City of New Bedford

STAFF REPORT

Case #18-35: SITE PLAN REVIEW

100 Duchaine Boulevard
Map 134 Lot 5

100 Duchaine Blvd
Looking towards proposed location for addition (east elevation)

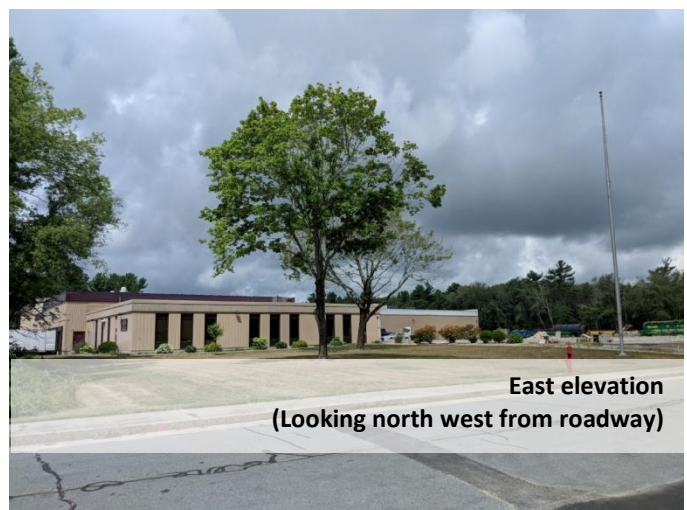
The current proposal before the board adds a 27,500± SF addition on to the east side of the building. The addition is proposed to be installed on a section of an existing slab concrete foundation of a previously demolished building. Two overhead bay doors are proposed on the north side of the addition. A connecting hallway (19' wide x 15' length) near the south west corner of the addition will connect it to the main building. No additional site alterations are proposed other than the building.

Snow/Trash Removal. The proposed site plan identifies two areas for snow disposal: one on the northwest side in a grassed lawn area and along the north side of the proposed east addition. The City Conservation Agent has noted the proposed northwest snow storage area should be relocated to be outside of the 100' wetlands buffer. Planning staff notes that snow storage areas are not identified for the parking areas on the east side nor the south side loading areas.

snow storage area is proposed within the 100' Buffer Zone in the northwest corner of the site and should be relocated elsewhere. Further, the building is within several feet from the 100' Buffer Zone and the applicant needs to demonstrate to the Conservation Commission that work to construct the building will not extend into the Buffer Zone. Lastly, the comments note that no stormwater facilities are proposed for the new building. If the Planning board decides to require stormwater management the Conservation Commission would like to review the revised plans.

- The temporary construction driveway entrance on the east side of the site is returned to a grassed area after the completion of construction.
- Snow storage areas to be revised and located outside of the 100' wetlands buffer zone.
